Conversion Kit Cap Protection

Subject: Removal of the standard protective bracket, and
installation of the deflector item no. 361.998.907

The standard deflector

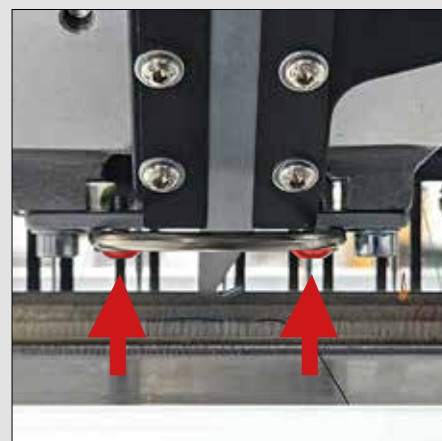
The bracket [1] is a safe deflector, but takes up a lot of valuable space.

Carefully loosen and remove the screws. The protective bracket can now be easily removed.
